RADFORD UNIVERSITY

BMP Inspection Report

Project Number: 2429.3

Date: August 30, 2024

RU-BMP-CU-1 - DETENTION POND

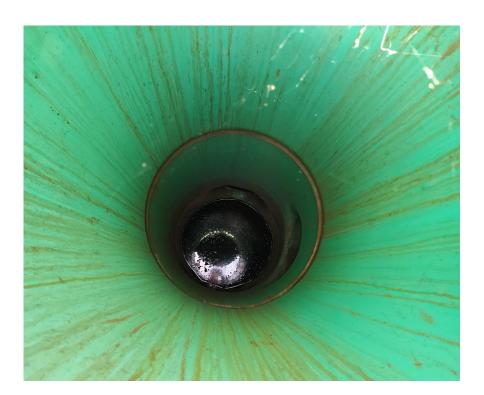
- > Overall facility is in good condition with no signs of erosion near the roadway.
- > Recommend increasing the schedule for vegetation removal along the slopes. Excess vegetation in a few areas.
- Debris and sediment found near the riser orifice. Sediment blocks lower orifice from functioning. Remove immediately. Recommend a new trash rack be installed to help with sediment build up conditions.
